[Docket No. FAA-2023-1814; Project Identifier AD-2023-00773-T; Amendment 39-22541; AD 2023-17-14]

Airworthiness Directives; The Boeing Company Airplanes

ACTION: Final rule; request for comments.

Figure 1 to paragraph (h)(4) – Cap seal minimum thickness (all dimensions in inches)

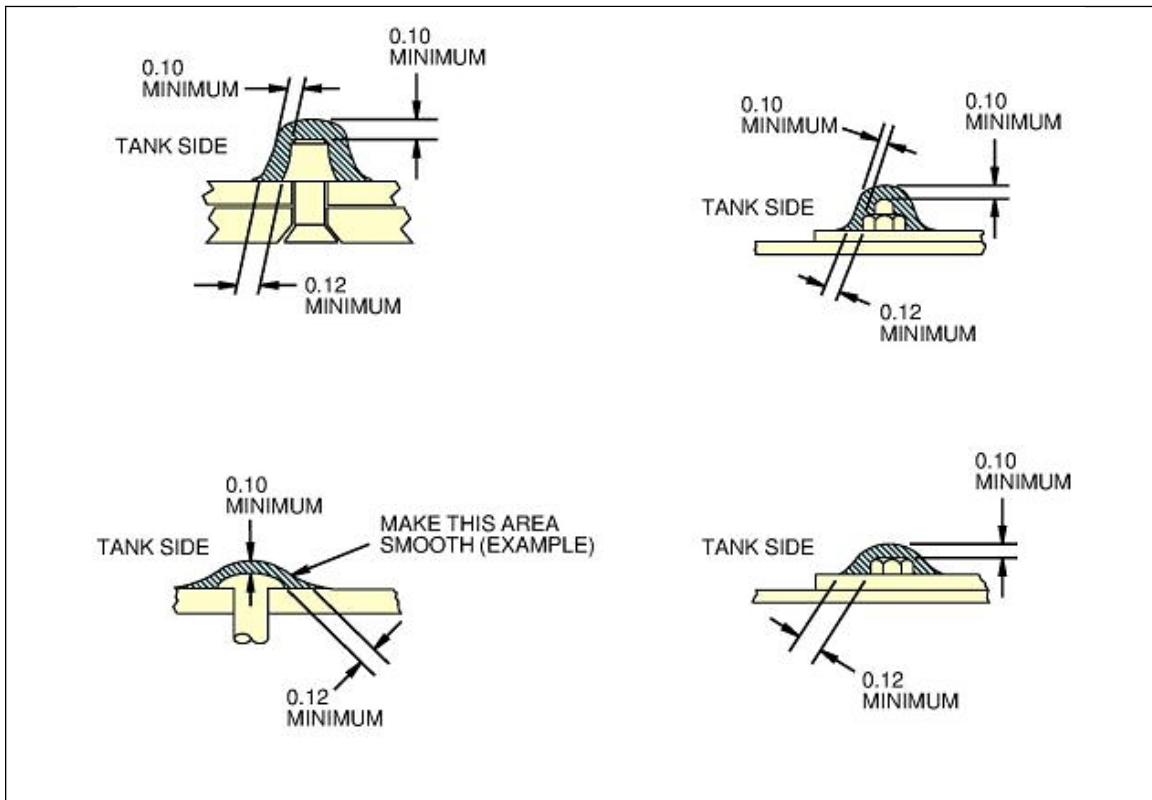
(4) During application of any cap seal to a fastener, fastener head, and fastener threads and collars, as required by this AD, the cap seal must be applied with a thickness equal to or greater than the dimensions specified in figure 1 to paragraph (h)(4) of this AD.

this AD requires that if the cap seal is removed, a cap seal of BMS 5-45 sealant be reapplied with a thickness equal to or greater than the dimensions specified in figure 1 to paragraph (h)(4) of this AD before further flight after completion of the inspection.

(2) If any cap seal was applied using procedures with thickness dimensions less than those given in figure 1 to paragraph (h)(4) of this AD, or if the maintenance records do not definitively specify the procedures used: At the applicable time specified in paragraph (i)(2)(i) or (ii) of this AD, replace the cap seal in accordance with the Accomplishment Instructions of Boeing Alert Requirements Bulletin 777-57A0122 RB, dated October 8, 2021, using a cap sealing procedure with thickness greater than or equal to the dimensions given in figure 1 to paragraph (h)(4) of this AD.

(3) For any cap seal that was not applied, or for any cap seal that was removed for inspections and not replaced, or if the maintenance records do not definitively specify the procedures used: At the applicable time specified in paragraph (i)(3)(i) or (ii) of this AD, apply a cap seal of BMS 5-45 sealant using an accepted method with thickness greater than or equal to the dimensions given in figure 1 to paragraph (h)(4) of this AD.
